UNITED STATES PATENT AND TRADEMARK OFFICE

Office Action Summary

10/022,383

DETAILED ACTION

Figure 1 - U.S. Patent 5,852,646 to Klotz et al.

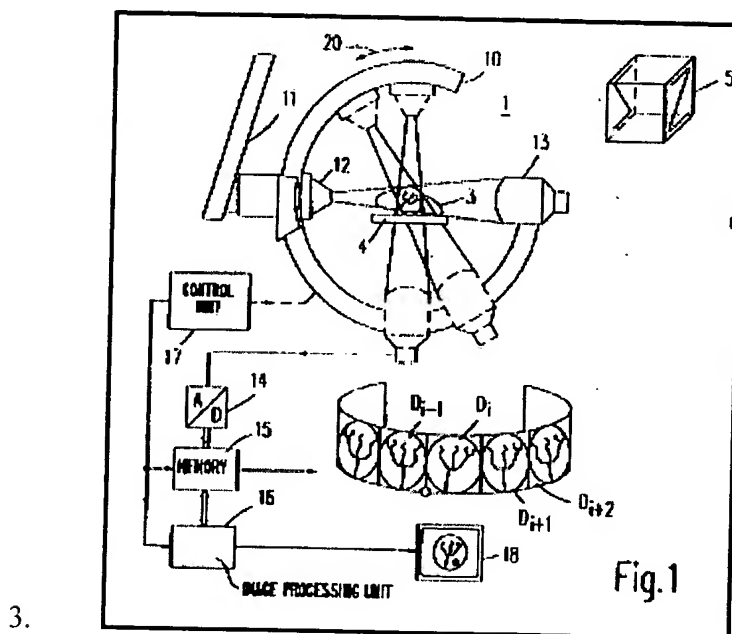
4. As per claims 1 and 6, Klotz et al. disclose a method (and apparatus) comprising: forming a set of 2-dimensional images (18) of an object (3) to be examined, by means of a scan rotation of an X-ray source (12) around said object over a run length (20).

5. Klotz et al. do not explicitly disclose a method wherein X-ray images are acquired at predetermined moments in a cardiac cycle of the object and reconstruction of a 3-dimensional volume thereof wherein the run length of the scan rotation over 180 degrees is at least 15 seconds and preferably about 20s and reducing the number of measuring points in successive cardiac cycles.

Figure 1 - U.S. Patent 6,324,254 to Pflaum

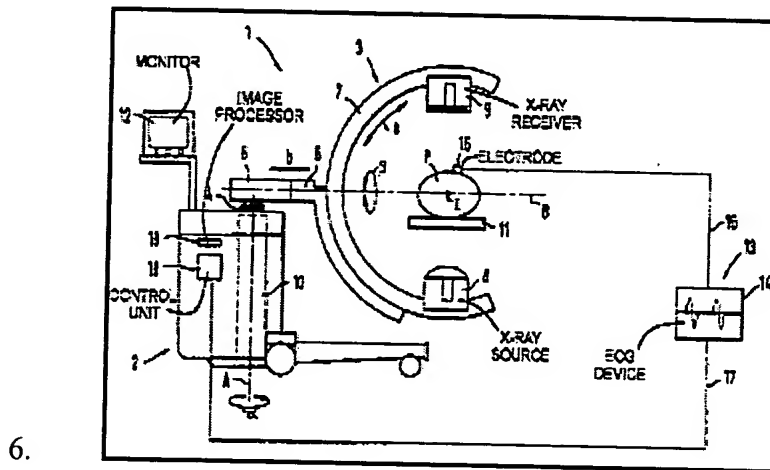
7. Pflaum discloses a method wherein X-ray images are acquired at predetermined moments in a cardiac cycle (abstract, column 2, lines 52-58) and wherein reconstruction of a 3-dimensional volume occurs as a result of the scan rotation occurring over 180 degrees and at least 15 seconds (column 2, lines 17-32).

Figure 1 - U.S. Patent 6,266,553 to Fluhrer et al.

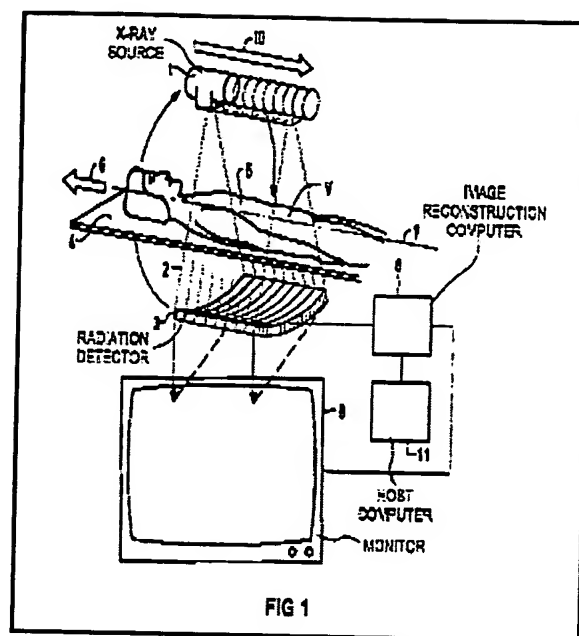
9. Fluhrer et al. teach a method wherein the selection of a particular portion of a cardiac cycle (i.e. the diastole) results in a reduction of the number of measuring points in successive cardiac cycles. Fluhrer et al. teach that such selection also results in imaging containing low motion artifacts, and results in reduced radiation exposure to a patient or object of interest (column 1, lines 64-67, column 2, lines 1-2, 5-9).
